BOARD MEETING
DATE REQUESTED: JUNE 1, 2016 MILLIGAN SUBDIVISION

NAME & NUMBER OF PROJECT: C8J-2015-0176.0A (D-10)

MEMORANDUM

SUBJECT: Milligan Subdivision
C8J-2015-0176.0A

Exhibit 5-1 - Proposed Lot Layout and Proposed CEF Buffers

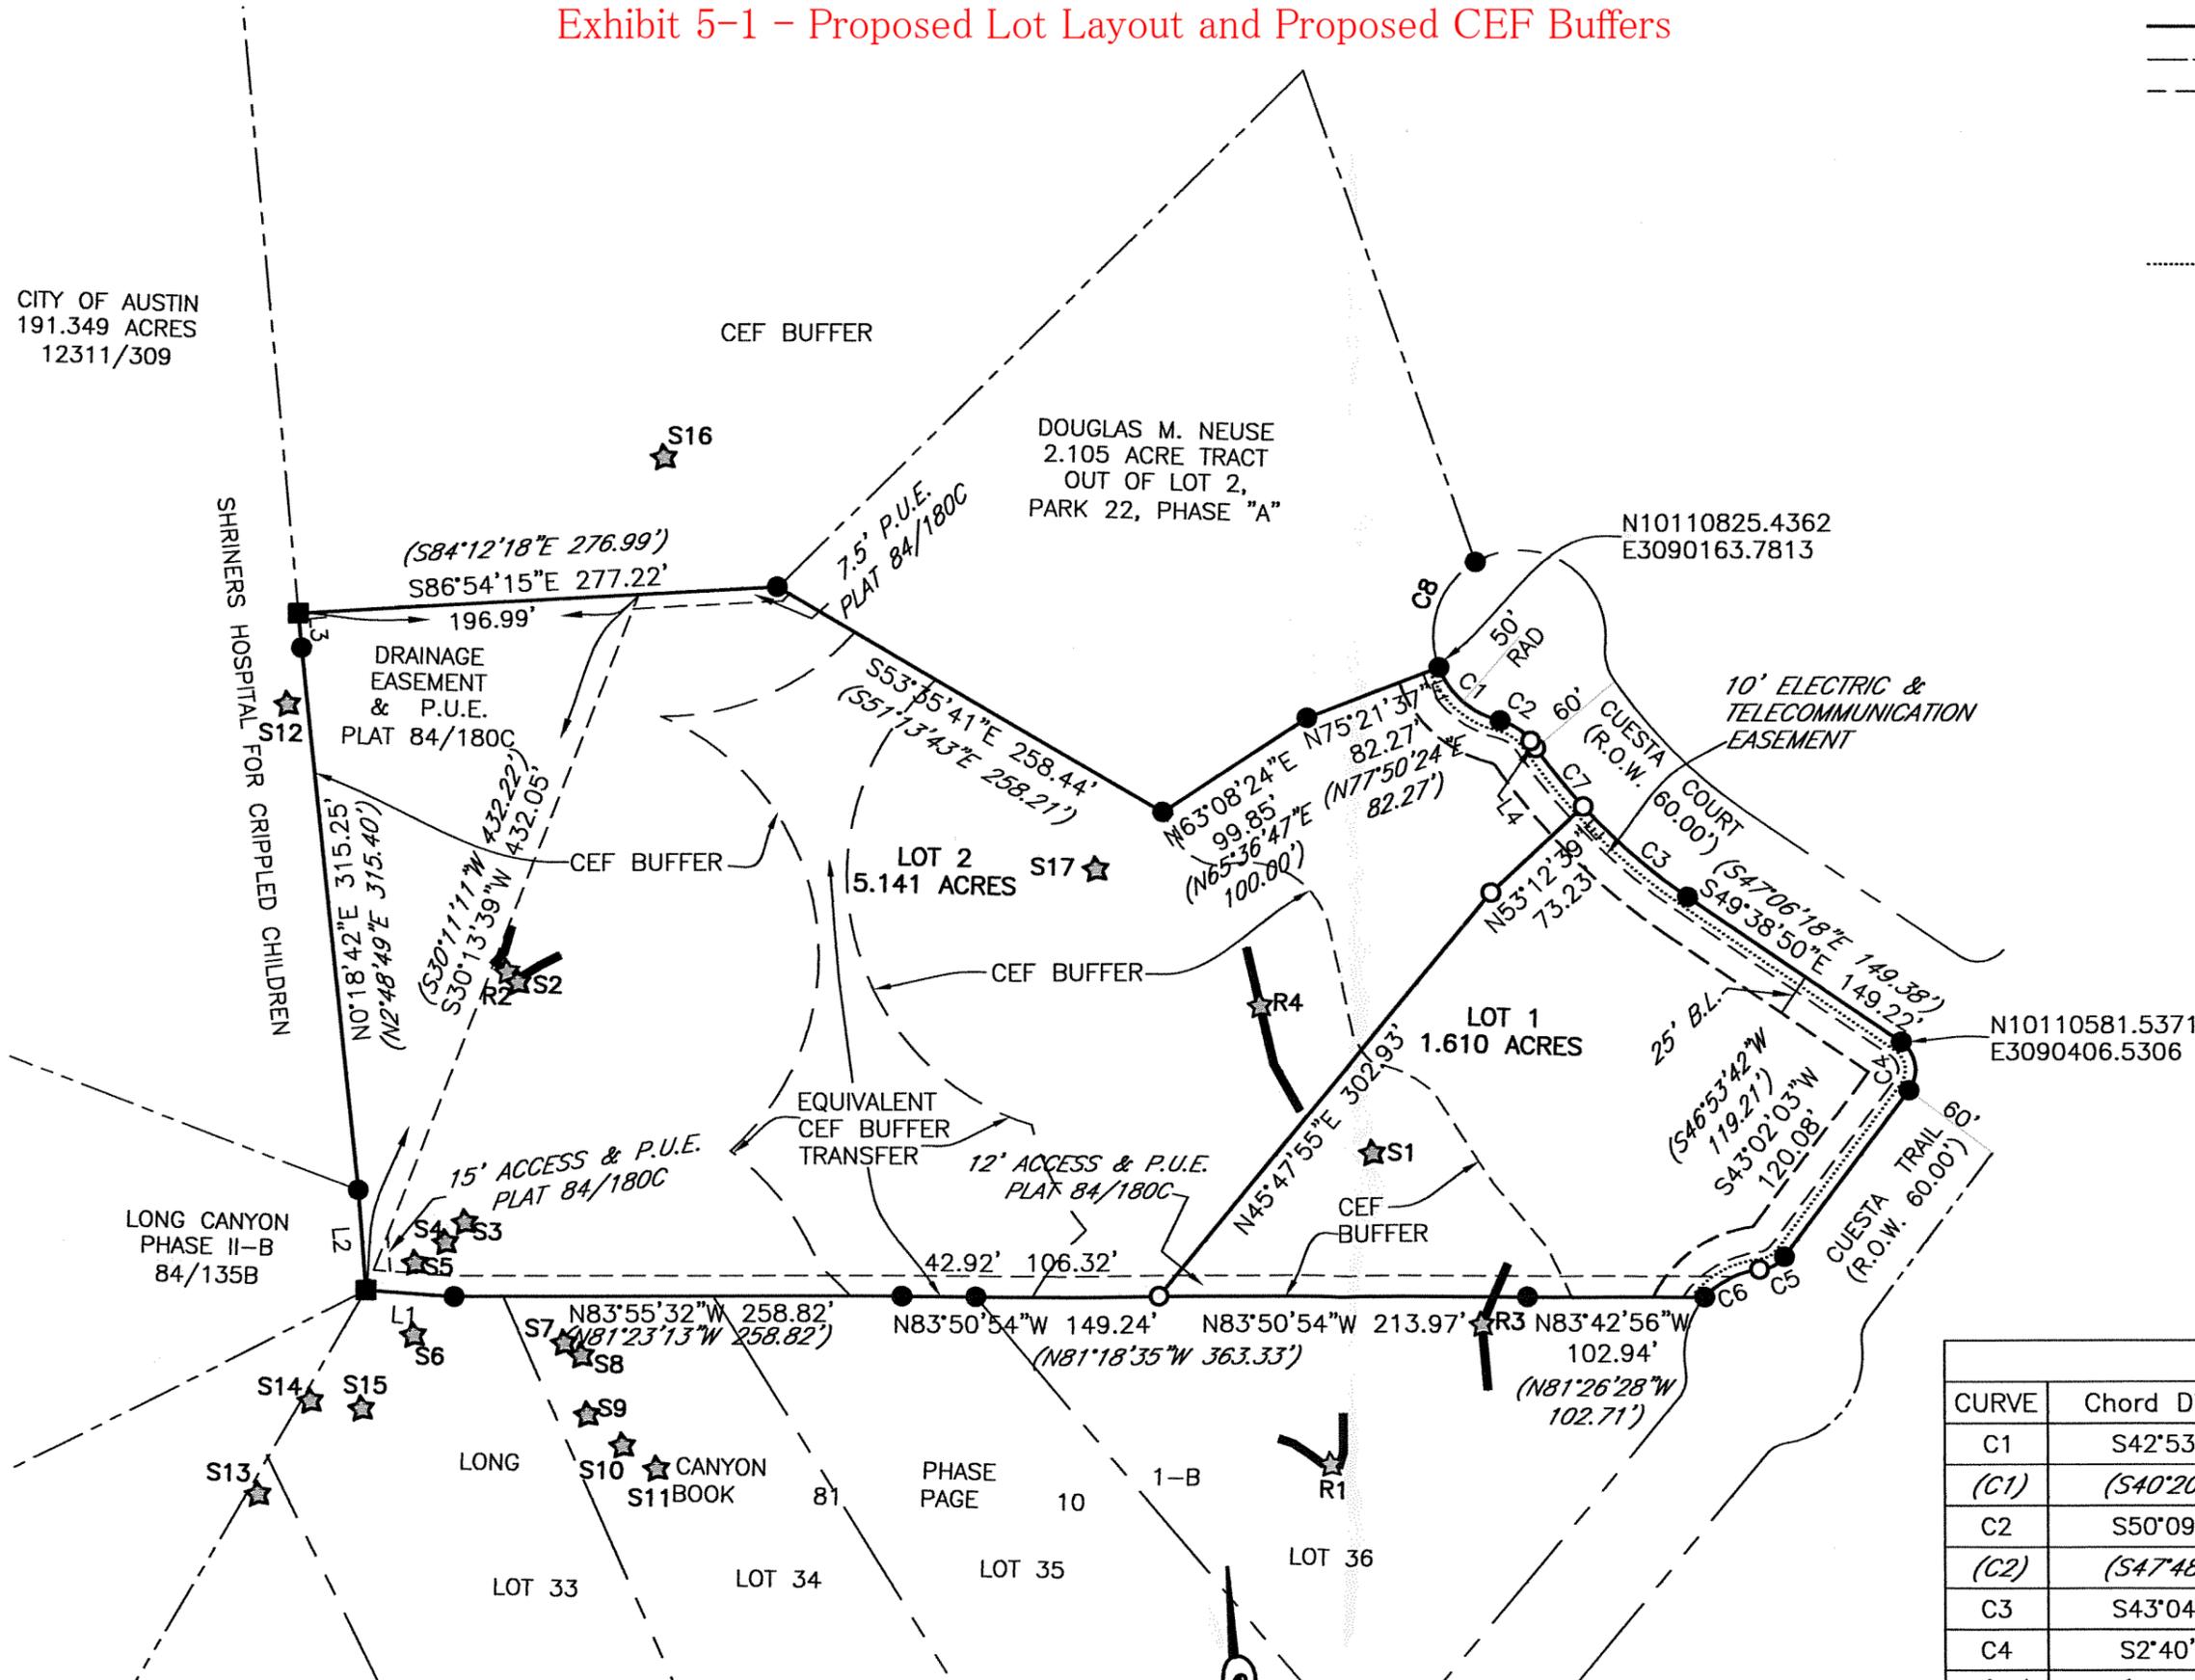
LDC 30-5-281(C)(1)(a) requires a standard 150 foot radius CEF buffer. The applicant is seeking to reduce this standard 150 foot radius buffer to a 50 foot radius buffer for two of the CEFs located within the subdivision. CEFs R4 and S17 are proposed to have 50 foot radii buffers on Lot 2. The applicant proposes to expand the CEF buffers towards the center of Lot 2 in order to mitigate for the reduced CEF buffer area on the eastern portion of the lot. The proposed CEF buffer and the proposed CEF buffer expansion are shown on Exhibits 5-1 and 5-2 - Proposed Lot Layout and Proposed CEF Buffers.

- 1 – To allow seven CEFs to be located within a single family residential lot [LDC 30-5-281(B)]; and
- 2 – To reduce two CEF buffers (R4 and S17) to a 50 foot radius [LDC 30-5-281(C)(1)(a)] from the standard 150 foot radius.

1. An area equal to or greater than the area of reduced from a standard 150-foot radius CEF buffer be dedicated as CEF buffer in the central portion of Lot 2. The mitigation area will provide an equivalent area for water quantity and quality to sustain baseflow to springs and unclassified tributaries of West Bull Creek.
2. The existing structure located within the CEF buffer mitigation area will be demolished and removed and the area restored with native grasses and plants.

CEF REQUIREMENTS PER LDC NUMBER 2

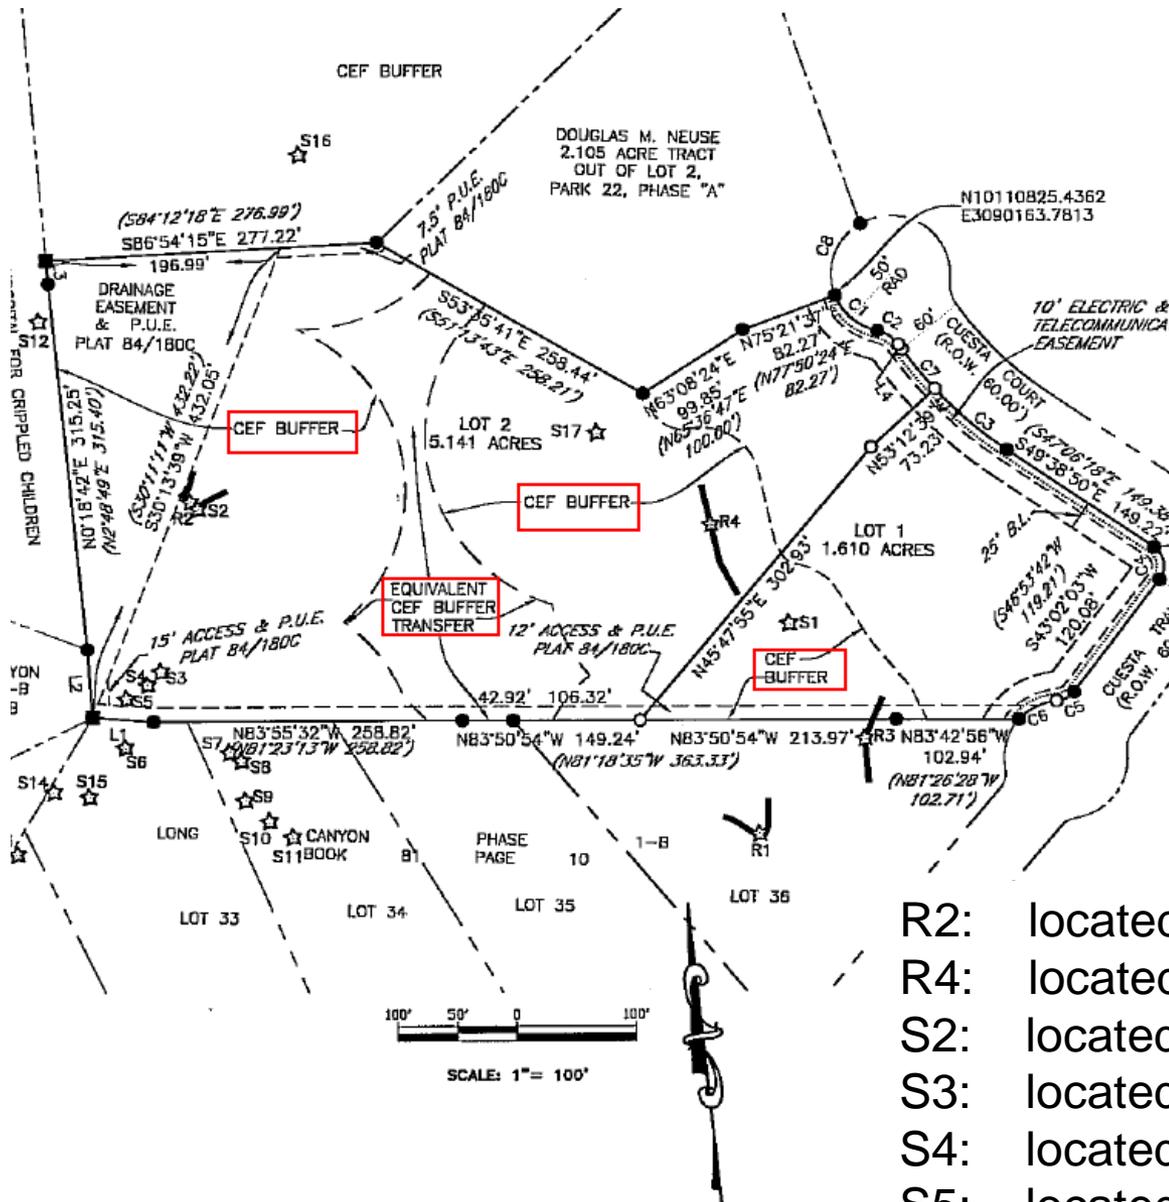
- LDC 30-5-281(C)(1)(a) requires a standard 150 foot radius CEF buffer.
- *Applicant proposes to reduce the CEF buffer to from 150 feet to 50 feet on the proposed Milligan Lot 2.*

Staff recommends approval of the above variances provided that:

1. An area equal to or greater than the area of reduced from a standard 150-foot radius CEF buffer be dedicated as CEF buffer in the central portion of Lot 2. The mitigation area will provide an equivalent area for water quantity and quality to sustain baseflow to springs and unclassified tributaries of West Bull Creek.

2. The existing structure located within the CEF buffer mitigation area will be demolished and removed and the area restored with native grasses and plants.
